Zoning Challenge and Appeal Form

RE: 264 West 46th Street
Block: 1017. Lot 1
Job number: 121208326

- 1) UG 15 or Coney Island-style rides are not accessory uses to hotels. (12-10 “Accessory Use” and “Transient Hotel,” BSA Appeal 128-14-A)
- 2) There are “mechanical” floors that do not use all of the floor area for mechanical purposes. (12-10 “Floor Area,” BSA Appeal 315-08-A)
- 3) The application requires a CPC special permit (32-02(d)).
- 4) The proposal is unclear because there are basic errors in the ZD1.

Axonometric of proposed building and existing buildings to stay on the zoning lot using traditional land use colors and predominate use. Entirely mechanical floors are shown in gray.

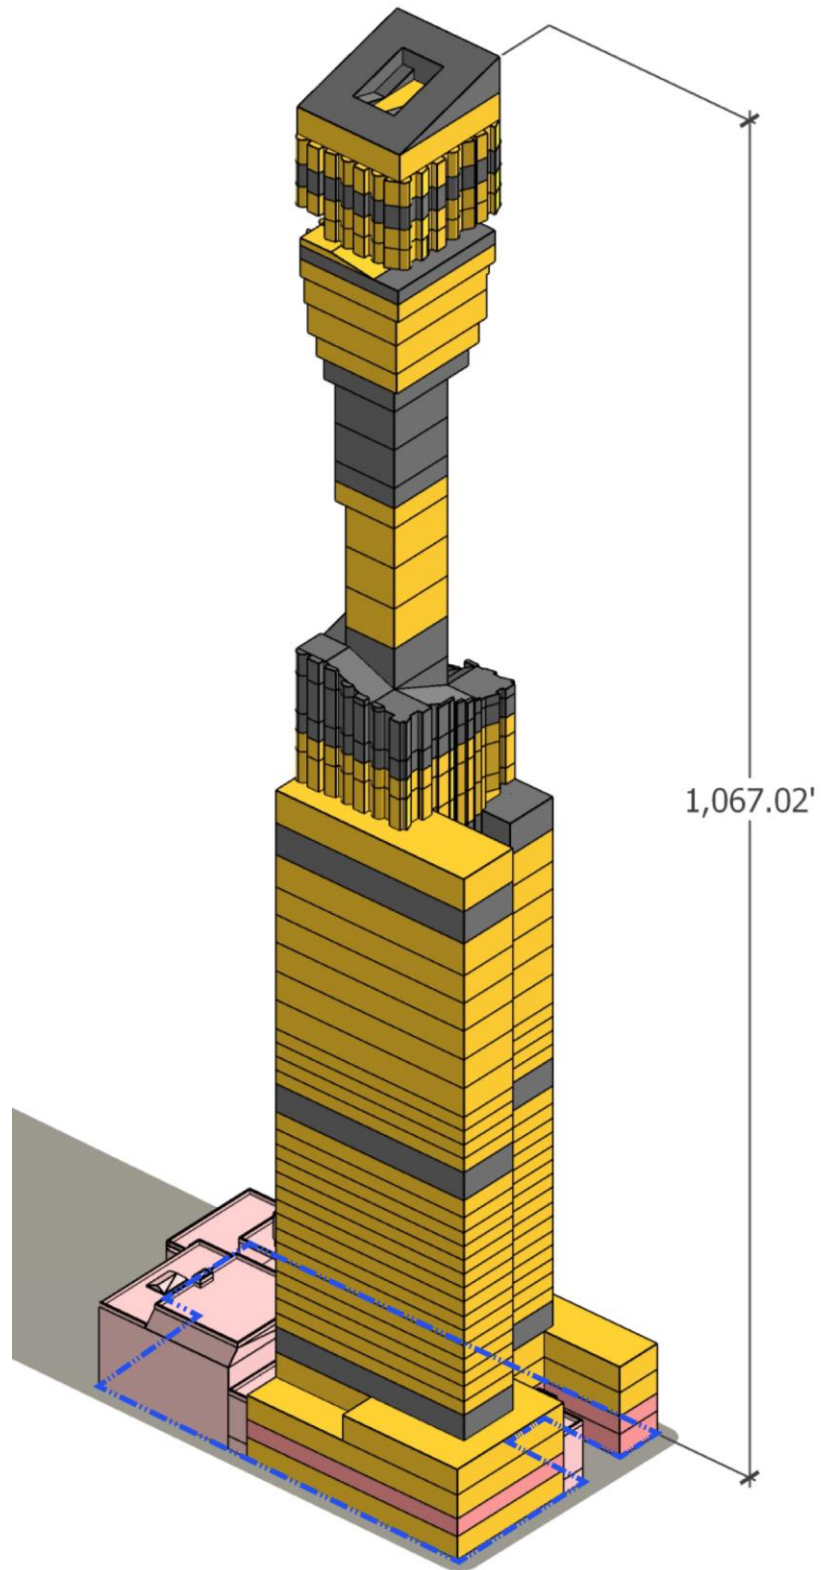
As can be seen in the above image, the building is roughly broken into two parts: the bottom half of the building, which contains the vast majority of the floor area and all of the hotel rooms, and the top half of the building, which has uses that are accessory to the hotel.

Detail of section found in CCD1 73182

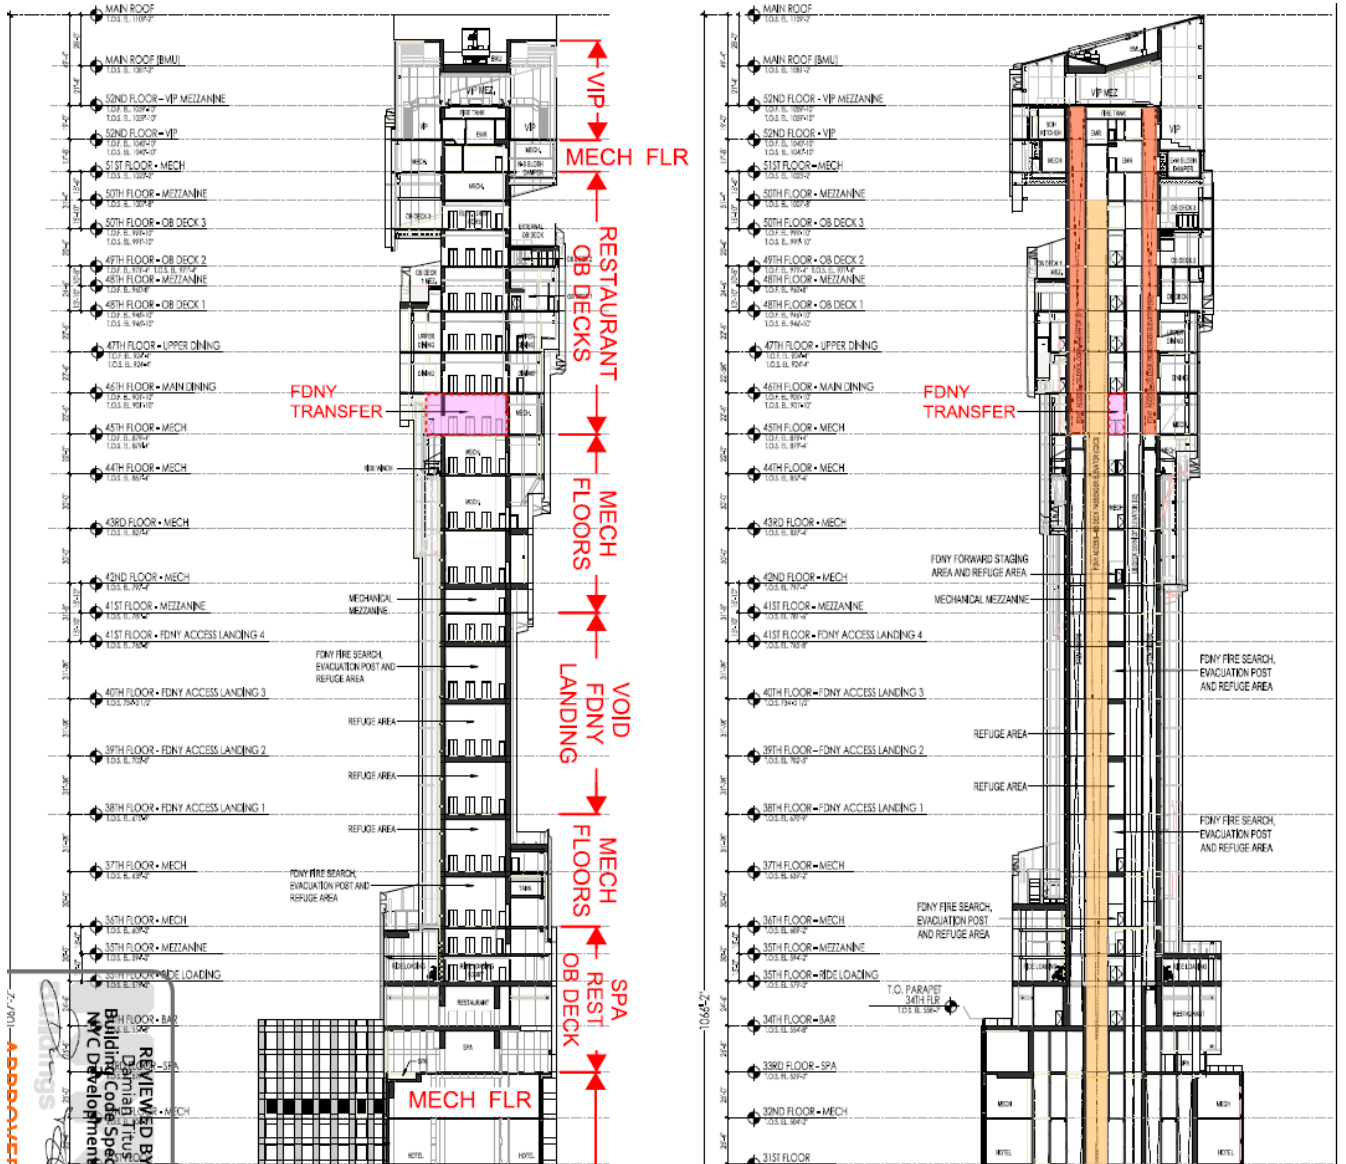
The stem alternates between mechanical floors, which the ZD1 shows as having zero zoning floor area, and “VOID FDNY LANDING,” which are shown as having some zoning floor area.

The CCD1 shows FDNY uses on floors that have been deducted entirely for mechanical purposes. Floor 36 shows zero zoning floor area, but is labeled as “FDNY FIRE SEARCH, EVACUATION POST AND REFUGE AREA.” Floor 37 has the same label and zero zoning floor area. Floor 40 has the same label, but has some zoning floor area. Floor 42 is shown as a mechanical floor with zero zoning floor area, but which also houses: “FDNY FORWARD STAGING AREA AND REFUGE AREA.”

Further, even on the mechanical floors in the stem that do not have an FDNY use listed, these floors are 30+ feet floor-to-floor. As you know, FDNY requires buildings to provide exits from stairs or elevators on these floors so that users of the stairs and elevators can exit the elevators and move to stairs or move from staircase to staircase. At 36 West 66th Street, the original design was altered to create small floors within spaces that had very tall floor-to-floor heights to allow this movement from elevator to stairs or from staircase to staircase. These “mini-floors” were counted as zoning floor area because spaces used for egress, hallways elevators and stairs are explicitly included in zoning floor area.

The same must be true here. If there are spaces used in the floors labeled mechanical designed to permit passengers and first responders to exit and move between elevators and stairs, then the floor can no longer be deducted in its entirety as a mechanical floor. The elevator counts as floor area; the stairs count as floor area; and any passageway connecting them count as floor area.

Reproduction of Exhibit A that appears in the ZRDI

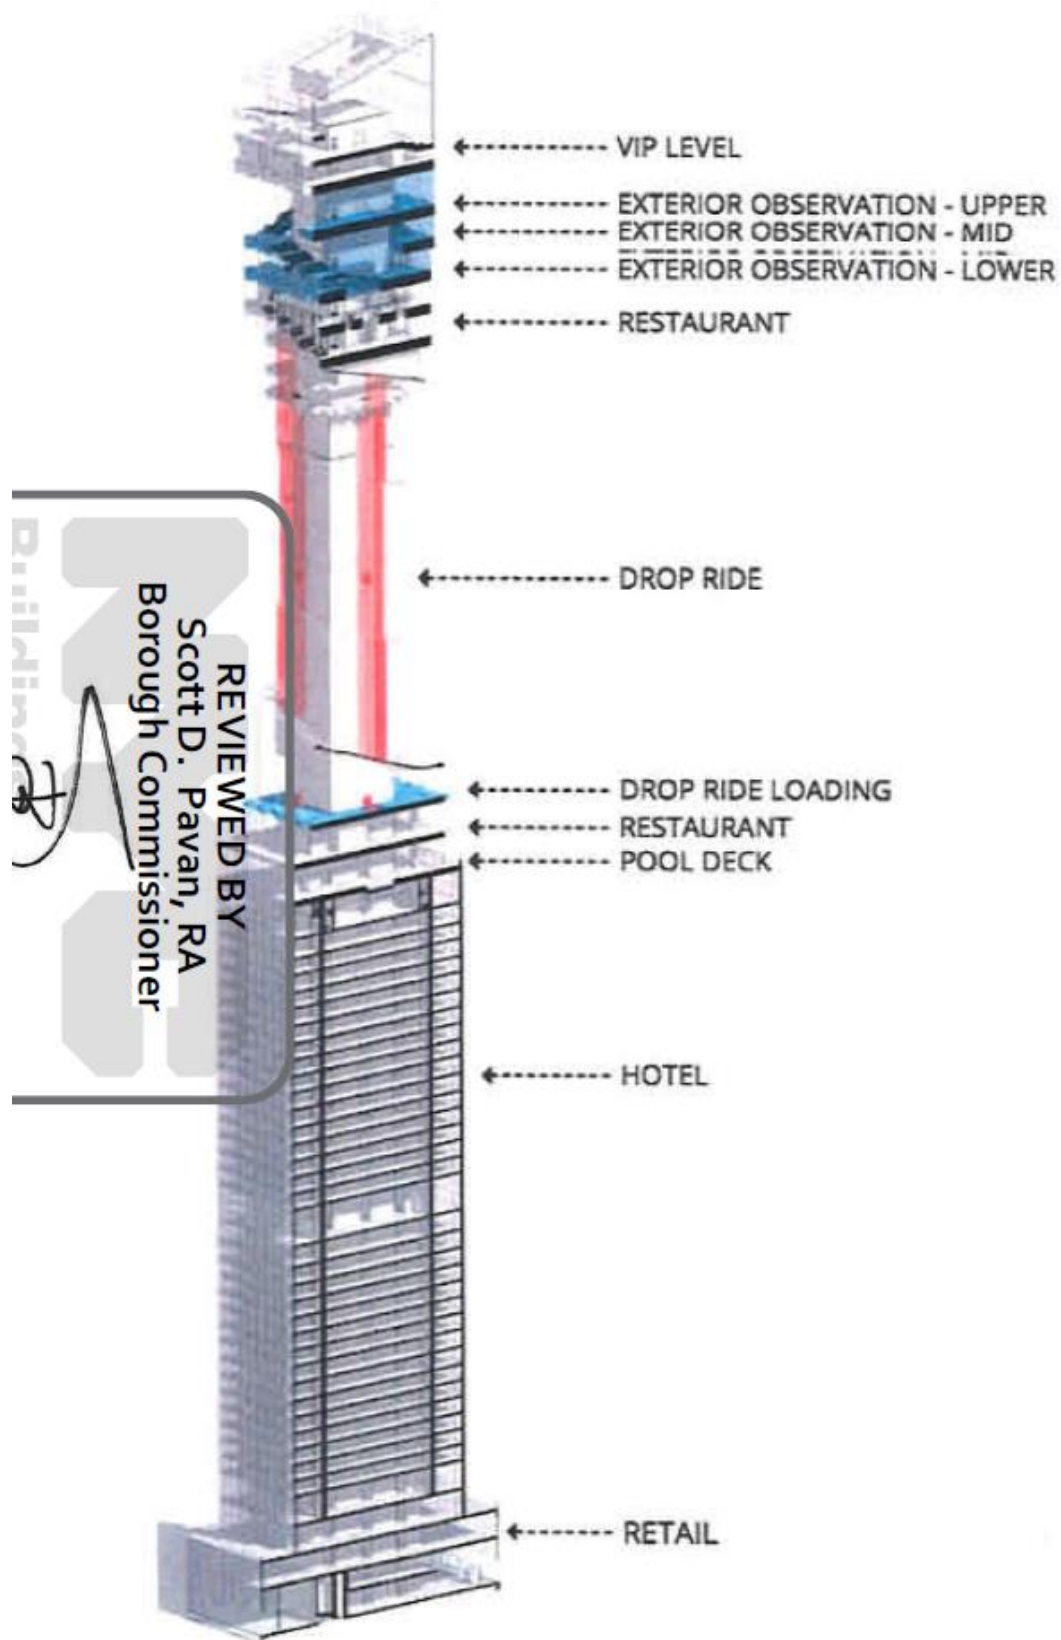
In addition to floor area used for FDNY purposes, the mechanical floors in the stem are also used by the drop ride. The following drawing is included as Exhibit A of the ZRD1 that describes the drop ride. The drop ride is attached to every floor that is also labeled as a mechanical floor and exempted from zoning floor area in the ZD1.

In addition to floor area required by the FDNY, these floors also have the accessory ride use associated with them. They cannot be considered solely mechanical floors, and so they cannot be entirely deducted from zoning floor area. As a result, the building is too large. The Department should rescind their approval and require the Applicant to account for the zoning floor area used in these floors.

Annotated plan and section from ZD1 showing discrepancy; numbers should be identical

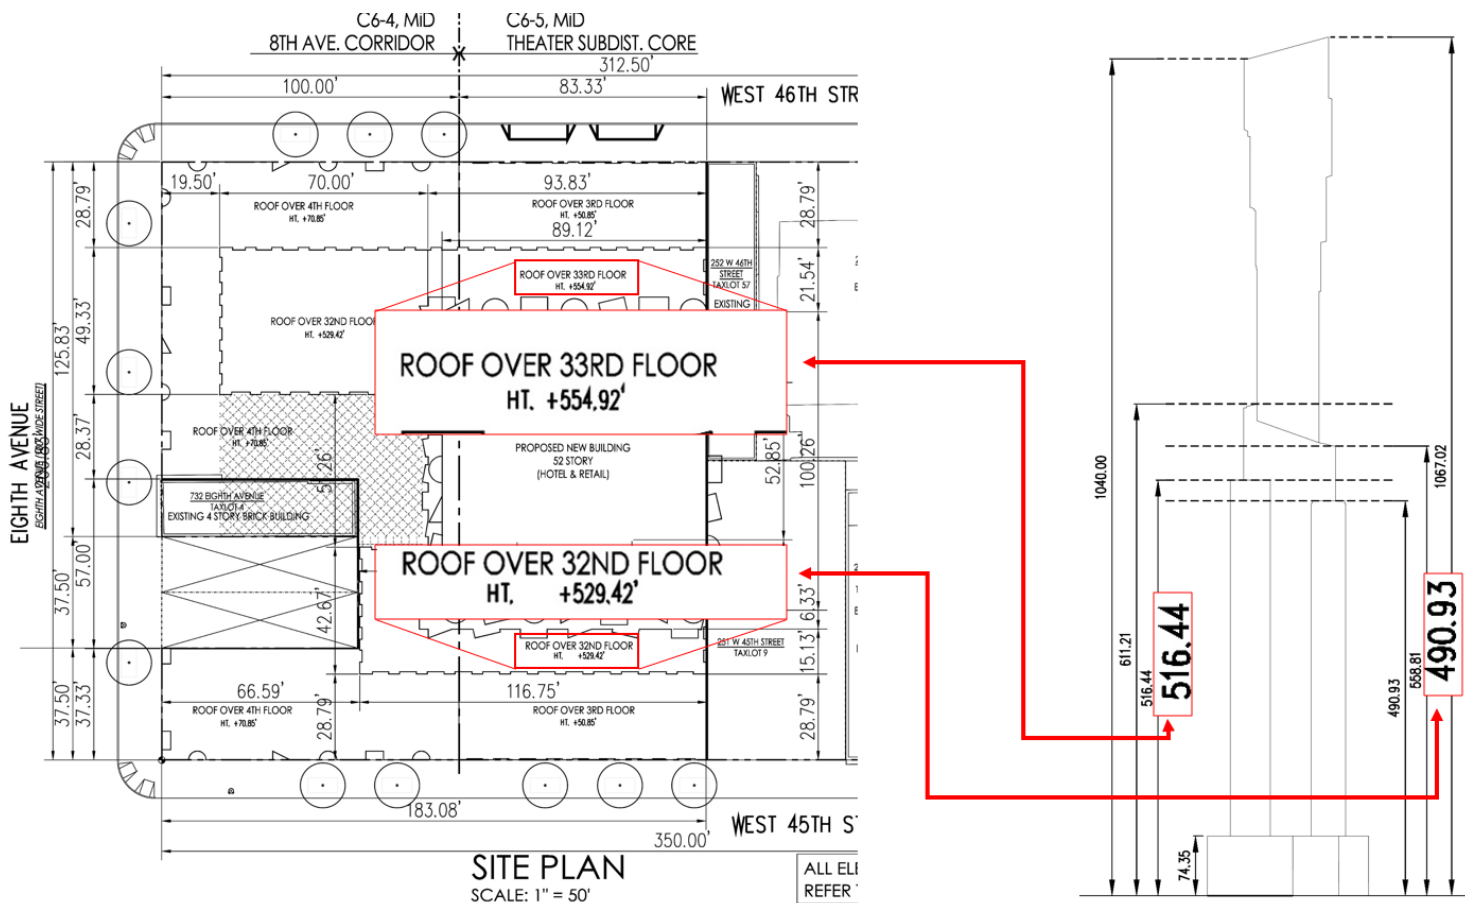
The building shown in the plan on the ZD1 does not match the building shown in section. Simply, the plan shows the lower half of the building as being substantially taller than as it is shown in section. The following graphic demonstrates the error.

The roof over the 33rd floor is 554.92 feet in plan, but it is only 516.44 feet in section. Over the 32nd floor, the building is proposed to be 529.42 feet in plan, but just 490.93 feet in section. Which building is the Applicant proposing? The Department and the public shouldn't have to guess. A new ZD1 should be required.
